MEMORANDUM

Re: Modifications to Planned Development and Design Review Approvals for The Harvey (PLNPCM2021-01092 and PLNPCM2021-01254)

PROPERTY ADDRESS: 501, 511, and 515 East 2700 South
PARCEL IDs: 16-19-476-059-0000, 16-19-476-060-0000, 16-19-476-061-0000
MASTER PLAN: Sugar House
ZONING DISTRICT: CN Neighborhood Commercial

REQUEST: The Harvey previously received Planned Development and Design Review approvals from the Planning Commission on February 9, 2022. The applicant requested modifications to the approved design that were approved by the Planning Commission on May 11, 2022. The applicant is requesting additional modifications. These changes are required by ordinance to be reviewed by the Planning Commission as only minor modifications can be approved administratively.

Approved Site Plan – This shows the garage and residential areas to be removed.

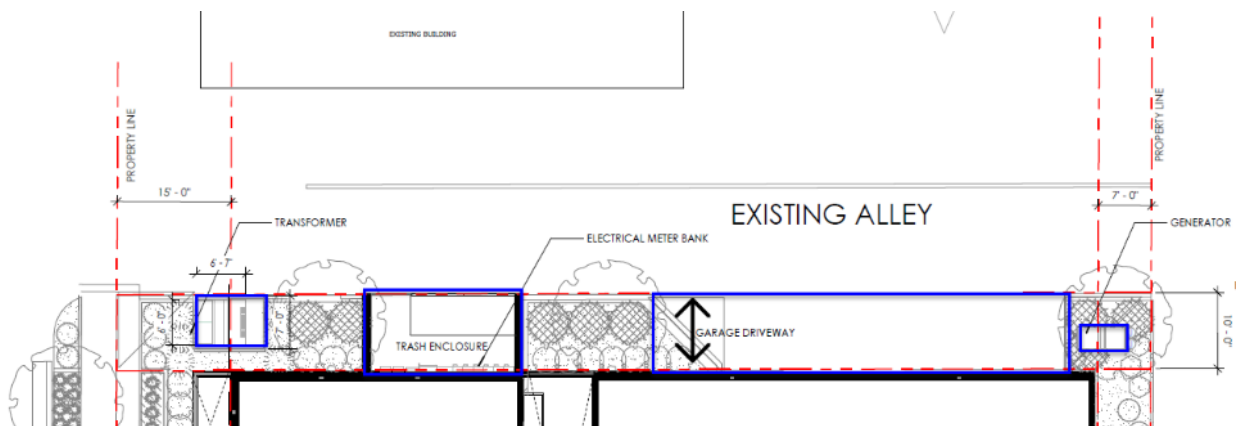
Approved Site Plan (partial) – The original Planned Development request included locating the utility transformer, trash enclosure, driveway, and generator (highlighted in blue) in the rear yard.

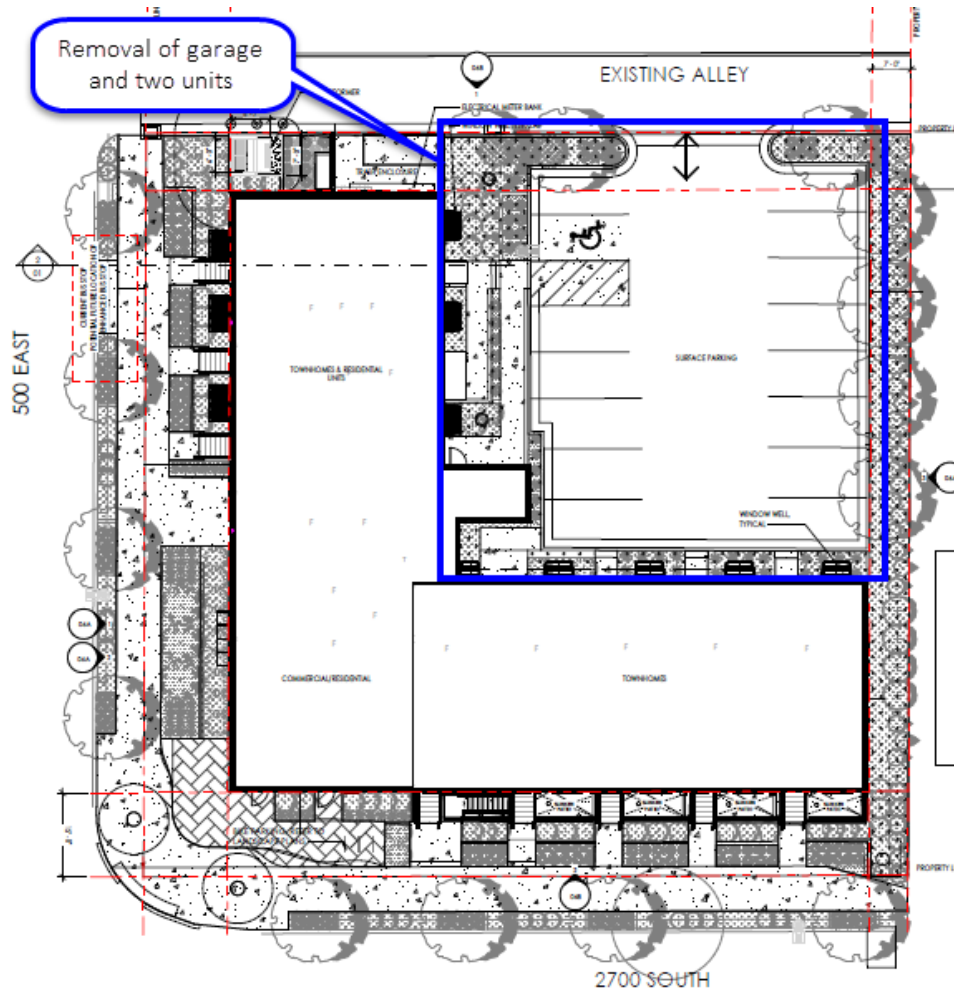
Approved Plans: Site Plan – Relevant to this request, the applicant initially requested Planned Development modifications for obstructions in the buffer yard and rear yard. The driveway was located to the north of the proposed building. The CN zoning district requires a 7' buffer yard when abutting a residential district. It also requires a 10' rear yard setback. The applicant requested a modification to allow the driveway in the buffer yard.

Proposed Site Plan – The site plan shows the removal of the parking garage, two residential units, and amenity area. The modification includes an additional request for waiver of the interior parking lot landscaping.

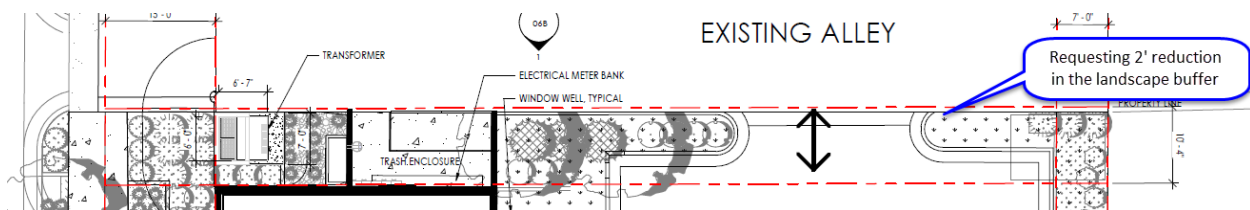
Proposed Site Plan (partial) – The modification includes an additional request for reduction from 7' to 5' for the landscape buffer yard on the north property line.

Proposed Plans: Site Plan – The proposed modification removes the parking garage with 29 automated stalls, the two residential units above it, and amenity areas. The 15-stall surface parking lot meets the parking requirements for the CN zoning district. The modification includes two additional requests:

Proposed Plans: 500 East/West Elevation – The northernmost window well decreased in size and is an egress window. Several of the second-floor windows changed from double hung to casement window openings to meet egress requirements.

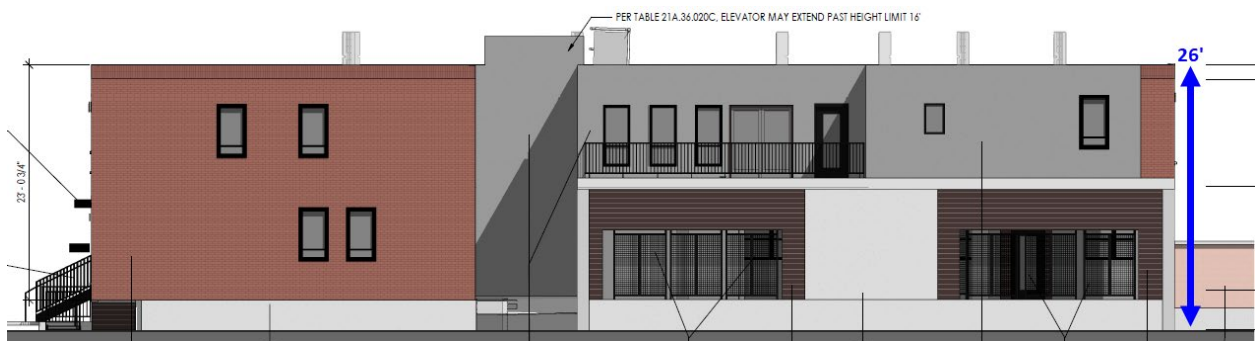
Approved Plans: 500 East/West Elevation – The applicant requested additional building height with the Planned Development for the sunken garden level patios, these were removed and replaced with window wells with the previous modification. This reduced the average building height from grade on this elevation to 26'.

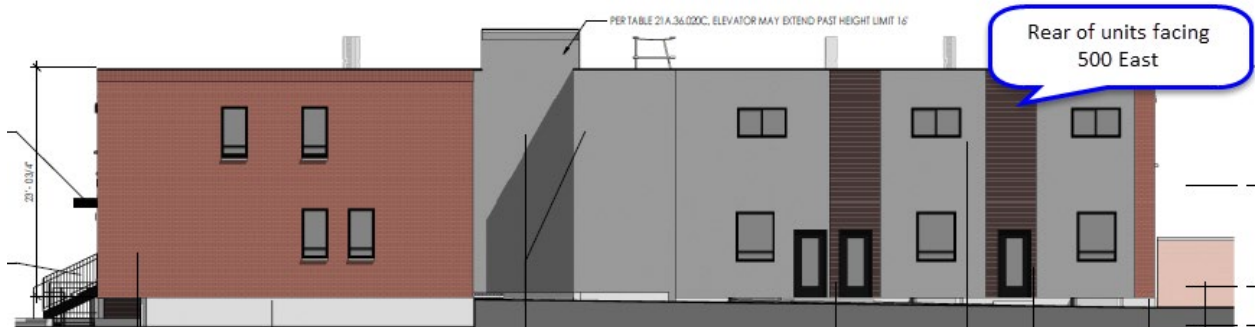
Approved Plans: North Elevation – The applicant requested additional building height from grade to the top of the parapet is 26'. The materials included brick, smooth concrete, fiber cement siding and brick cladding on the trash enclosure.

Proposed Plans: North Elevation – The proposal removes the parking garage and second floor residential units. The parking lot will be directly to the rear of the units that face 2700 South. The changes to location of the windows facing the alley are due to Rocky Mountain Power requirements and were approved with a minor modification during the building permit review process.

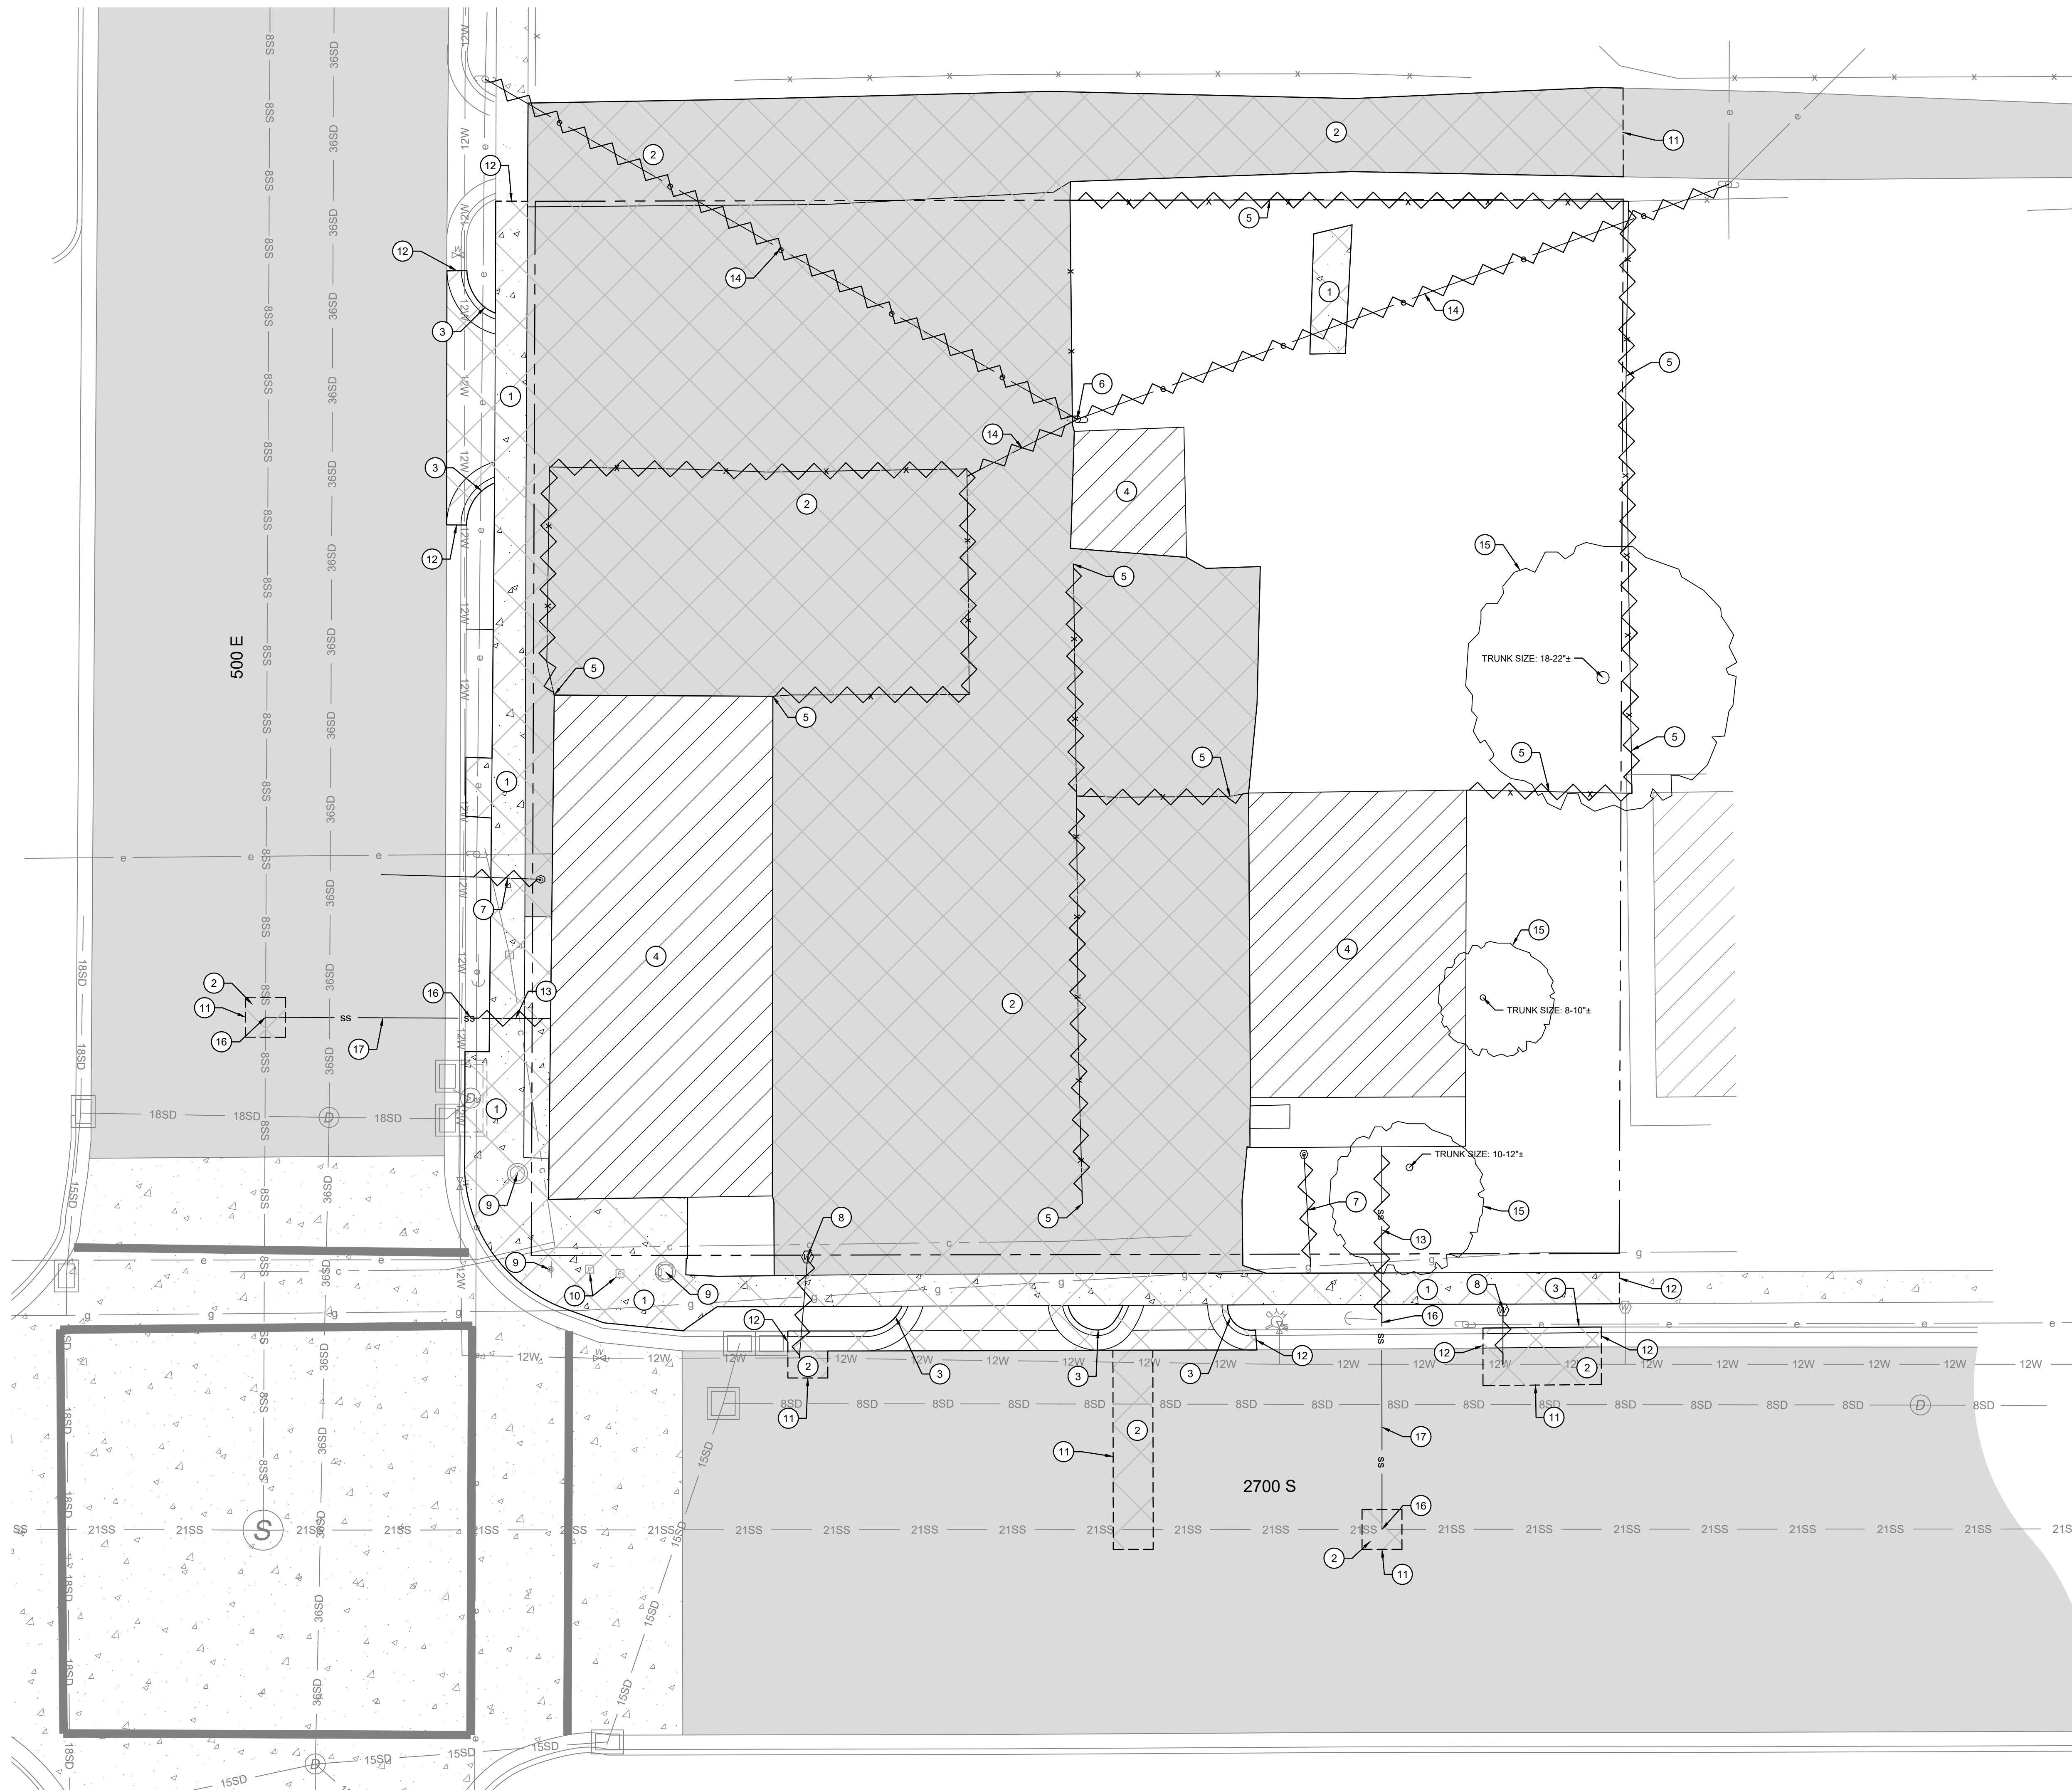
After removing two upstairs condo units, the total upstairs unit count is now four. Fire and building codes allow for a plan with just one stairwell and one elevator.

We are planning to remove one of the two stairwells, which will free up a little more square footage:

- One additional bedroom in the upstairs corner unit (now 2 beds instead of 1)
- Additional square footage for the ground level corner commercial/retail unit

Proposed Plans: North Elevation – Several material changes are proposed on this elevation:

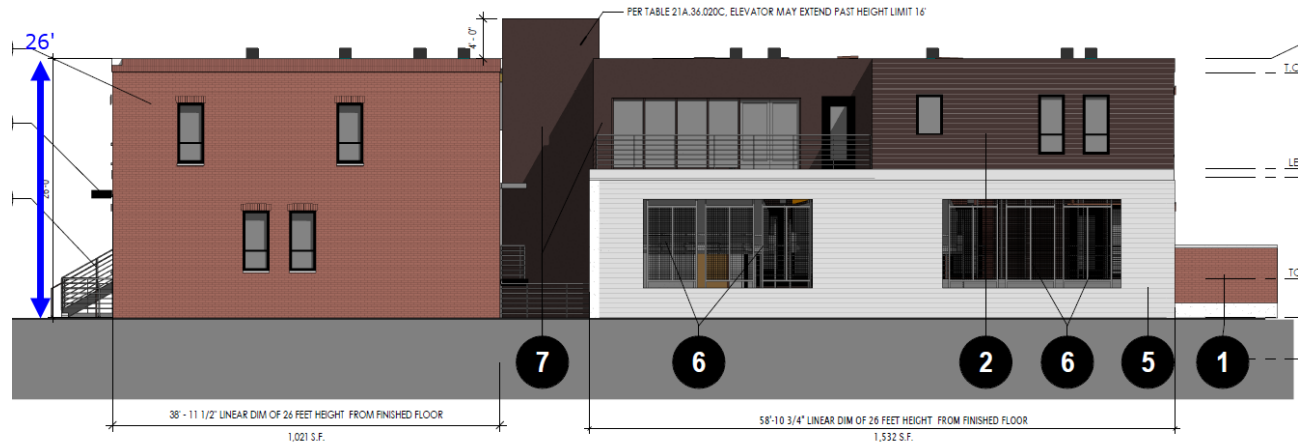
Approved Plans: North Elevation – The applicant requested additional building height from grade to the top of the parapet is 26’. The materials included brick, board form concrete, and brick cladding on the trash enclosure.

Proposed Plans: East Elevation – The applicant proposes material changes on this elevation as follows:

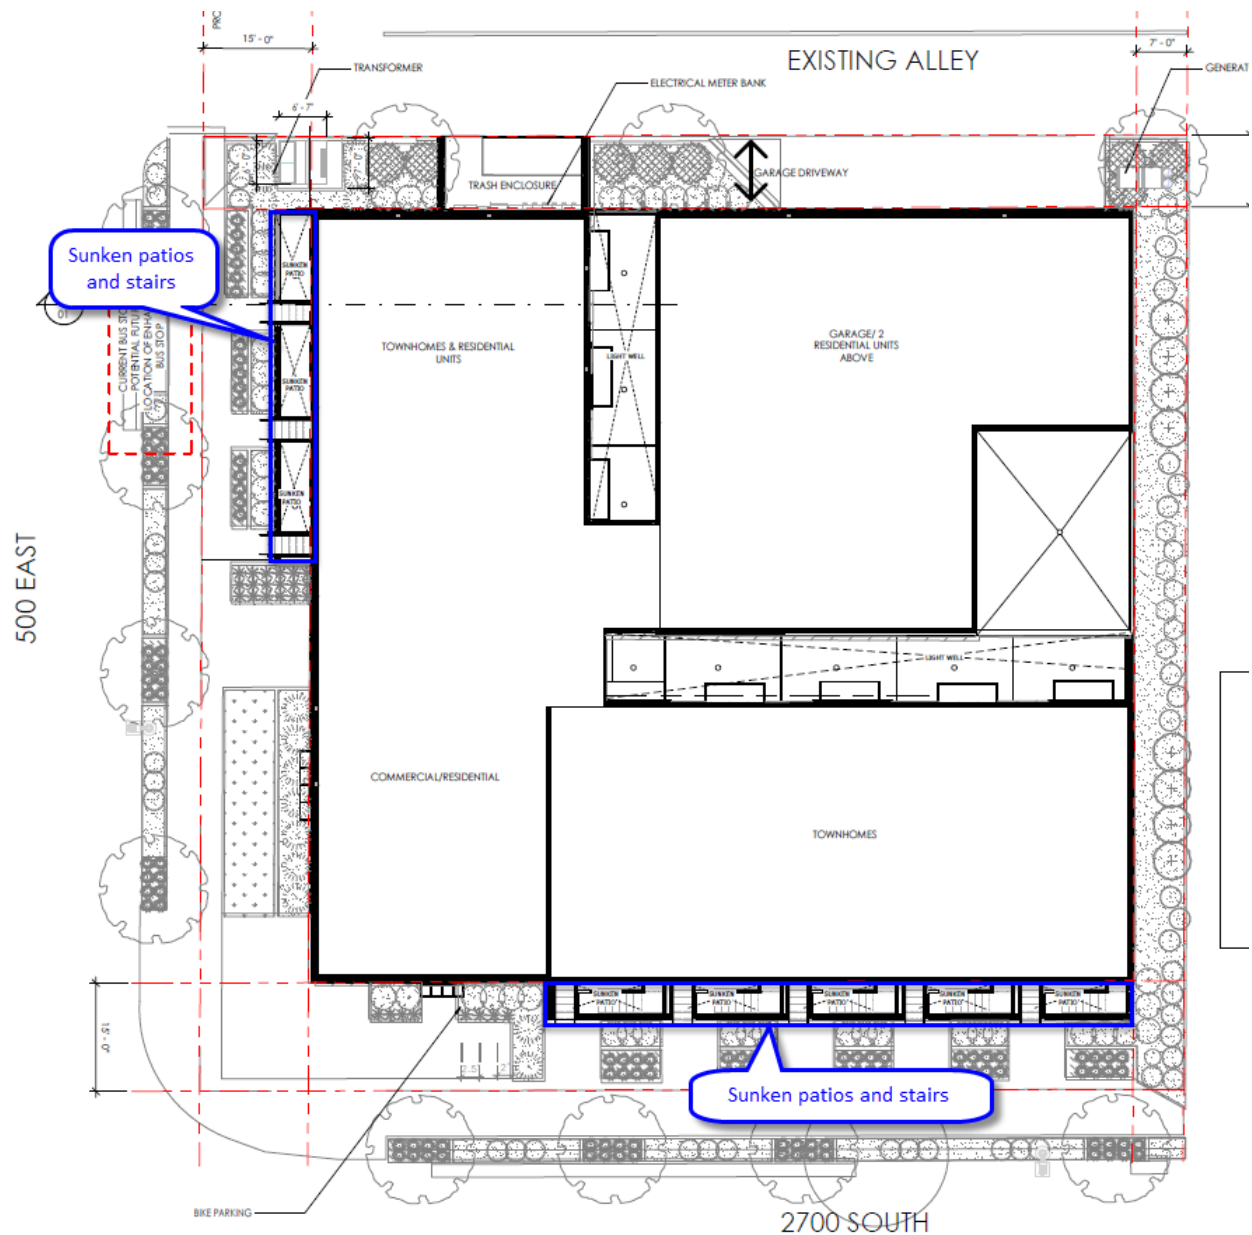
Approved Plans: East Elevation – The average building height from grade to the top of the parapet is 26'. The materials included brick, fiber cement siding, and board formed concrete.
